# UNITED STATES PATENT AND TRADEMARK OFFICE

APPLICATION NO.	FILING DATE	FIRST NAMED INVENTOR	ATTORNEY DOCKET NO.	CONFIRMATION NO.
10/720,278	11/25/2003	Alain Poiraud	2937-115	4789

<b>Office Action Summary</b>	<b>Application No.</b>	<b>Applicant(s)</b>	
	10/720,278	POIRAUD, ALAIN	
	<b>Examiner</b>	<b>Art Unit</b>	
	Ajay Vasudeva	3617

## DETAILED ACTION

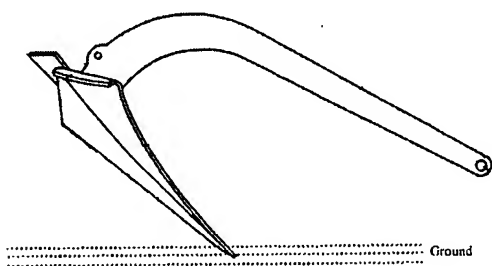
Re claims 5 and 12, in certain instance – such as when the anchor is tipped in an orientation shown below -- most of the weight of the anchor would be borne by the tip of the anchor. In such orientation, the proportion of the weight of the anchor on the tip would be higher than 20%. It is noted that claim 5 has not set forth the claimed weight distribution in an anchored position.

Alternatively, under certain other conditions – such as when the anchor is resting in an anchoring position on an sloped seabed/surface, and the tip of the fluke is positioned down slope – the proportion of the weight of the anchor on the tip would again be higher than 20%. Applicant may also note that a seabed is not always a level ground, and anchors are capable of settling in any one of countless positions on an uneven floor in which the weight borne by the tip of the anchor would be higher than 20%.
